TOLBERT ESTATES SUBDIVISION

APPLICATION NUMBER 14 DATE September 6, 2007

DETAIL SITE PLAN

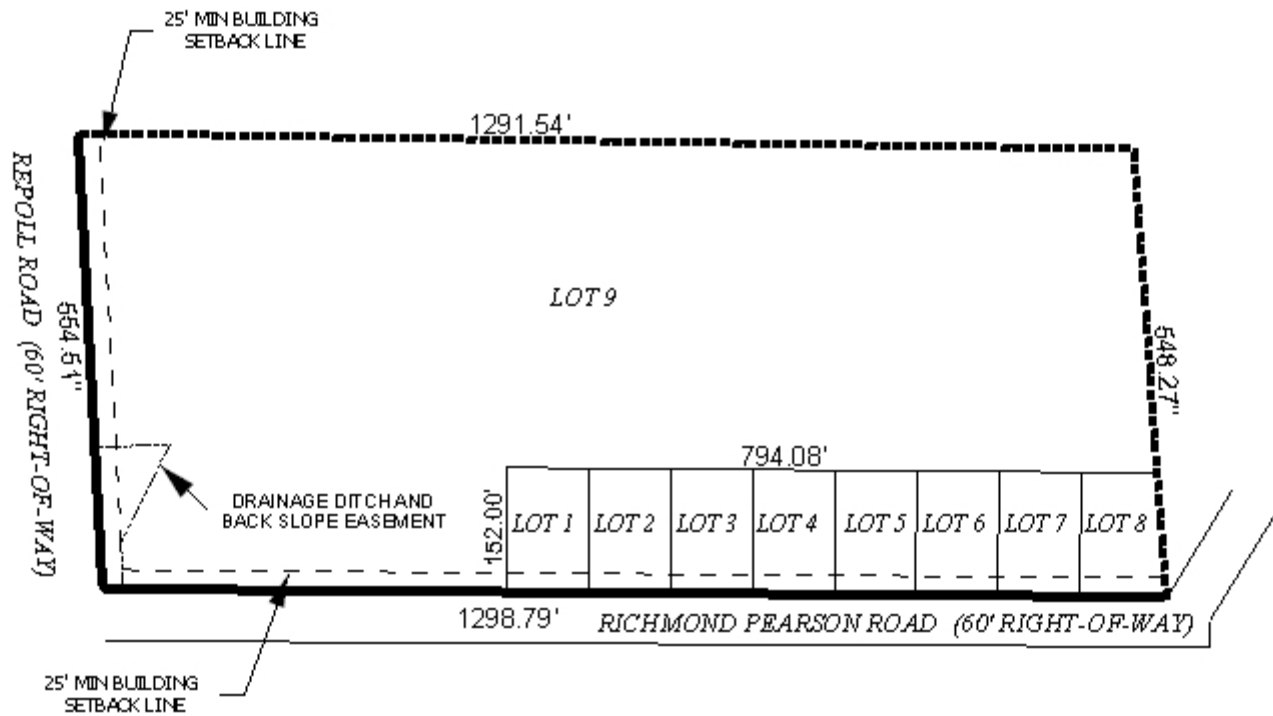
The site fronts Repoll and Richmond Pearson Roads, both minor streets with adequate rights-of-way. Access management is a concern, as proposed Lots 1-8 will only have 100 feet of frontage. Lots 1-8 should be limited to one curb-cut each, while Lot 9 should be limited to two curb-cuts onto Repoll Road and two onto Richmond Pearson Road. The size, design and location of all curb-cuts must be approved by the Mobile County Engineering Department.

Proposed Lot 9 has a corner at the intersection of Repoll and Richmond Pearson Road, thus the corner should be designed to comply with Section V.D.6. of the Subdivision Regulations. The plat should be revised to depict a corner with an appropriate radius, to be approved by Mobile County Engineering.

- 1) placement of a note on the final plat stating that Lots 1-8 are limited to one curb-cut each, and that Lot 9 is limited to two curb-cuts onto Repoll Road, and two onto Richmond Pearson Road, with the size, design and location of all curb-cuts to be approved by Mobile County Engineering;

- 2) revision of the plat to depict an appropriate corner radius at Repoll Road and Richmond Pearson Road, in conformance with Section V.D.6. of the Subdivision Regulations, to be approved by Mobile County Engineering;

- 3) depiction of the 25-foot minimum building setback line on the final plat, to accommodate condition number 2;
- 4) depiction of the lot size in square feet on the final plat, as depicted on the preliminary plat;
